AGENDA
PLANNING AND ZONING COMMISSION MEETING
CITY OF CREVE COEUR, MISSOURI
MONDAY, JANUARY 5, 2015
7:00 PM

#14-039 FOR A MASTER SIGN PLAN

FOR DESMET JESUIT SCHOOL

APPLICATION TO PLANNING AND ZONING COMMISSION
#14-041 FOR AN AMENDMENT TO THE CONDITIONAL USE PERMIT FOR
PLAZA MOTORS AND SITE DEVELOPMENT PLAN FOR THE RENOVATION
FOR THE PLAZA AUDI DEALERSHIP AT 11830 OLIVE BOULEVARD
FOR THE MEETING OF: January 5, 2015

Existing Sign-4A to be removed

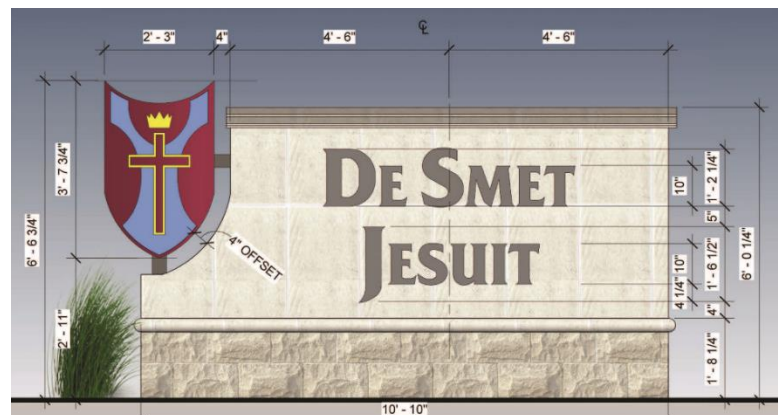
The existing campus monument sign along N. New Ballas Road (4A) will be removed and replaced with two 52.74 square-foot entrance signs at opposite sides of the entrance driveway (4B) at approximately 90 feet from one another. The same signs will be located at the entrance along Emerson Road (4C) for a total of four new monument signs. All signs will be located approximately 15 feet or more from the property line. Page 11 of the attached Applicant's Signage Plan provides a mock view of the two signs together.

The Design Guidelines offer further guidance in reviewing signs, by recommending that sign plans include a consistency of materials, siting, and design. Specifically, all signs are to be architecturally integrated and complement their surroundings in terms of size, shape, color, texture and lighting. Signs are to complement the overall design of the building and are not to be designed to be in visual competition with other signs in the area. New signs proposed for existing buildings should provide a compatible appearance with other building signage. Where no sign program exists there should be an attempt to bring in a unifying element (such as size). (Chapter 5, page 17). The proposed DeSmet signs are well-designed in similar style and use of materials, and limited to within the campus and away from the residential areas. For the most part, the master sign plan is consistent with the Comprehensive Plan and Design Guidelines. However, Staff has a concern regarding the total number of monument signs. The proposal includes maintaining the existing sign along Emerson Road, and adding four entry signs that are approximately 60 square feet each. This is out of character with a residential setting where, without such a plan, the campus would be limited to one sign of 24 square feet. Therefore, a condition of approval includes allowing only two similarly styles signs along Emerson Road. This would effectively require the elimination of sign #3 although one of the new signs could be placed in its pre-existing location if the plan is revised.

Figure 3: North Elevation

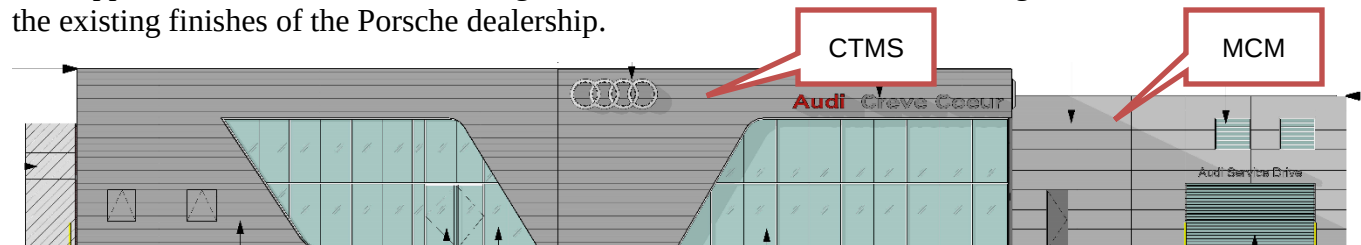
As the Applicant has indicated in their submittal, while the use of the materials is a requirement of the auto-franchise, however, the property owner has worked to create a unique setting for the City of Creve Coeur through the site design and bringing the building as far forward as possible. The angle of the building creates interest for those traveling east and west along Olive Boulevard. Overall, it is the Staff opinion that, given the nature of the applicant's business, the proposed addition succeeds in meeting the Comprehensive Plan and Design Guidelines to a high degree. The only exception, and thus a recommended condition of approval, is that the CTMS panels on the Audi showroom should end at the inside corner of the building, the MCM panels should be removed or limited to show the existing brick on the north elevation, and the existing aluminum coping on the parapet wall should be enlarged to match the existing horizontal MCM band.

showroom shall end at the nearest inside corner of the building adjacent to the service entry, the MCM panels shall be removed or limited to show the existing brick on the north elevation, and the existing aluminum coping on the parapet wall shall be enlarged to match the existing horizontal MCM band.

Figure 5: Close-up of Landscape Plan

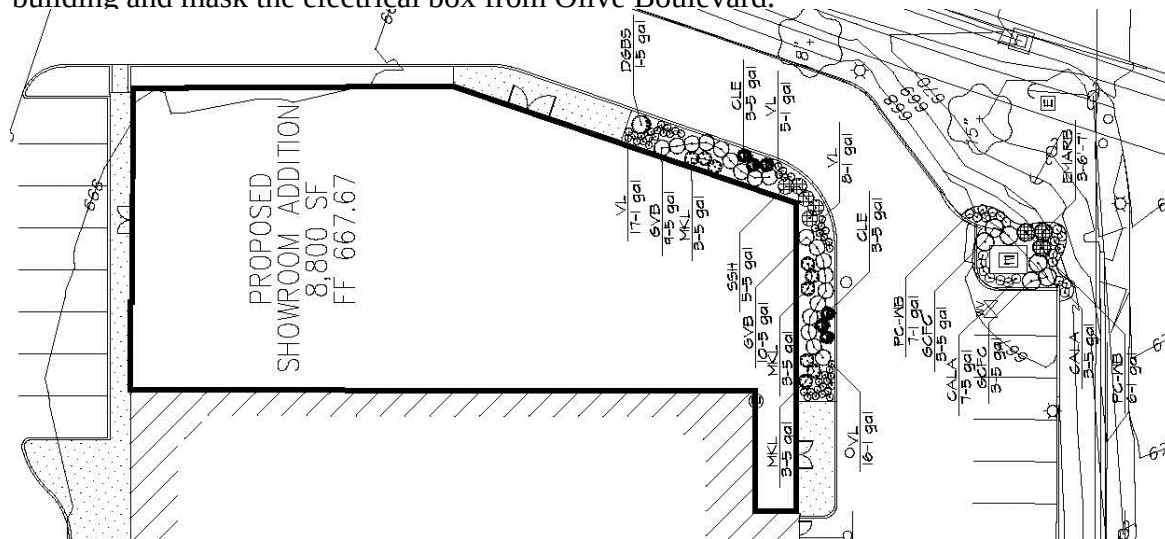
The proposal will create an additional 1,479 square feet of greenspace, where the lot has a pre-existing nonconforming site coverage. New landscaping will be provided along the south and east corner of the building and at the corner of the property to add to the visual interest of the building and mask the electrical box from Olive Boulevard.

Figure 9: Close-up of the site plan indicating distance from Olive Boulevard right-of-way

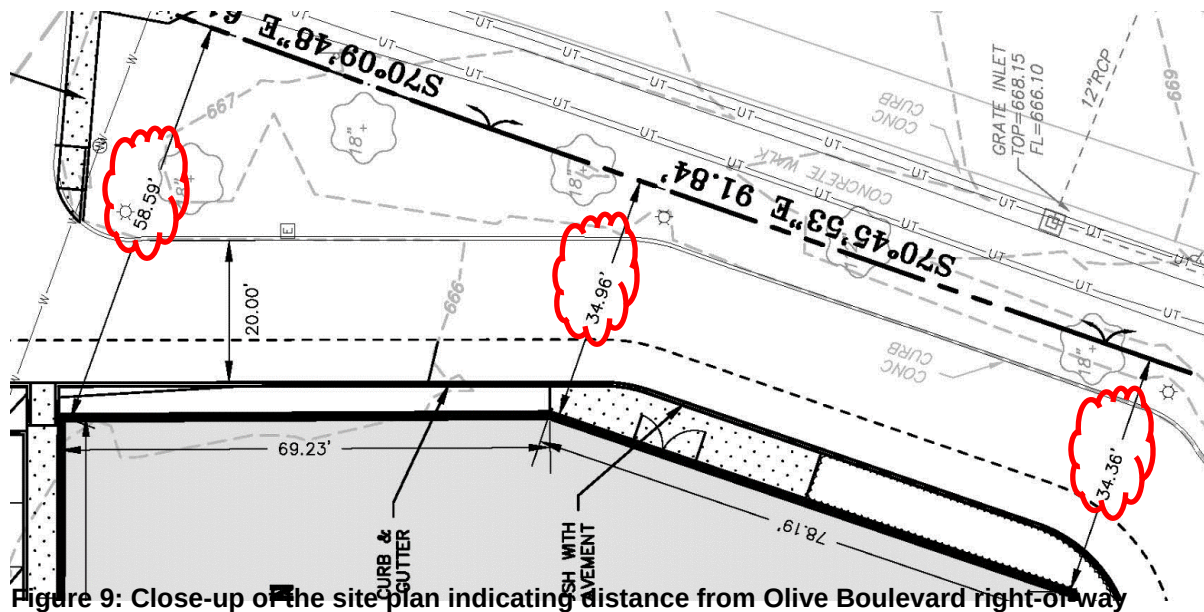
Maximum front yard: Section 405.370.E.4.a(2) requires that the maximum front yard setback fronting Olive shall be no more than 80 feet from the established right-of-way. The existing building is approximately 74 feet from the right-of-way at the west corner of the building and 35 feet at the east corner of the building. The proposed addition will move the western portion of the building closer to Olive Boulevard to approximately 58.5 feet at the north corner, 35 feet at the midpoint, and 34.4 feet at the eastern corner of the building. This is within the Council's discretion for approval and is a desirable improvement over existing conditions.
